Add 3" Drive jumper on 09FLP Ver: 02 / Ver:09

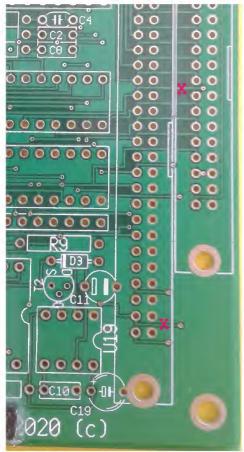
First cut the following two traces.

Then drill the 1.2mm holes for a 2x3 Pin Header.

The jumpers come below R5 for the use of Nextron P50 connector. Remove the ground layer with a 3mm drill on both sides.

Glue the 2x3 Pin Header on the print component side.

Clean the pins on the solder side.

Now connect the following wires:
